FROM Masoud Khodadadifard (Senior Transport Engineer, Ason Group)

SUBJECT Initial Transport Advice – 125, 145,155,165 & 175 Lawson Road, Badgerys Creek

Attachment 1 – Preliminary Design Commentary

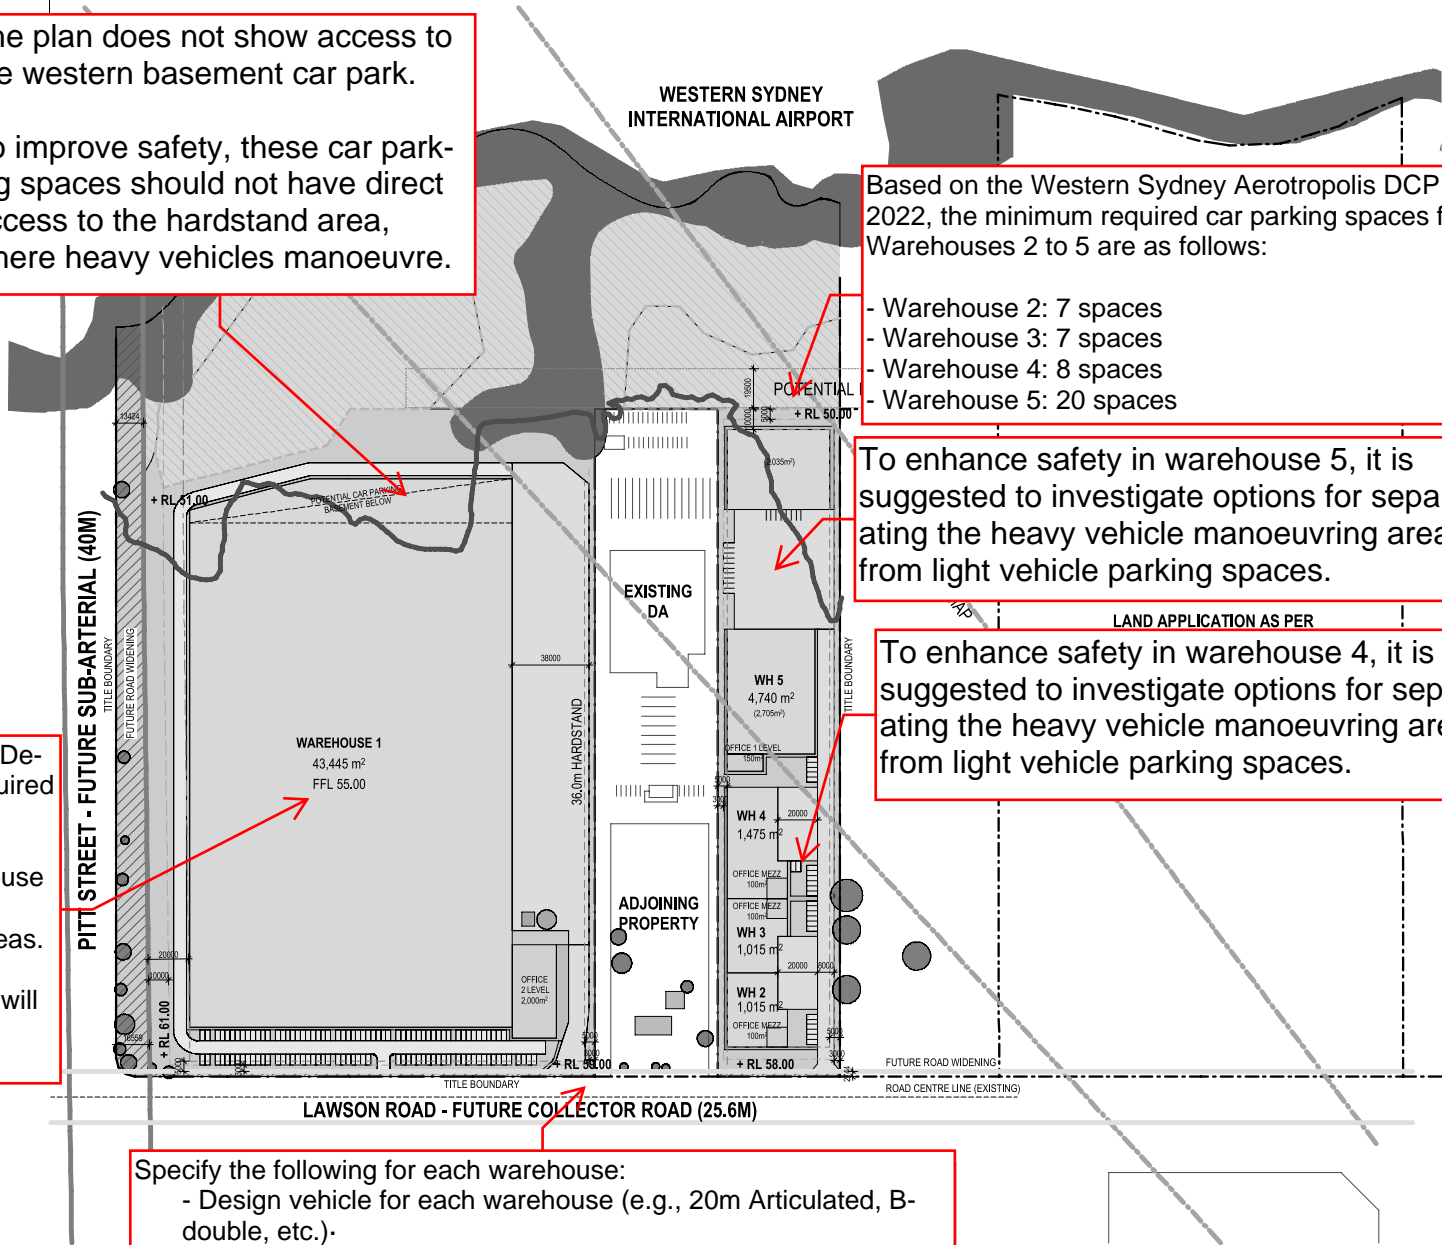
The plan does not show access to the western basement car park.
 To improve safety, these car parking spaces should not have direct access to the hardstand area, where heavy vehicles manoeuvre.

Based on the Western Sydney Aerotropolis DCP 2022, the minimum required car parking spaces for Warehouses 2 to 5 are as follows:
 - Warehouse 2: 7 spaces
 - Warehouse 3: 7 spaces
 - Warehouse 4: 8 spaces
 - Warehouse 5: 20 spaces

To enhance safety in warehouse 5, it is suggested to investigate options for separating the heavy vehicle manoeuvring area from light vehicle parking spaces.

To enhance safety in warehouse 4, it is suggested to investigate options for separating the heavy vehicle manoeuvring area from light vehicle parking spaces.

Specify the following for each warehouse:
 - Design vehicle for each warehouse (e.g., 20m Articulated, B-double, etc.)
 - Loading dock locations for each warehouse
 - Grades and gradients for areas where RLs are changing.
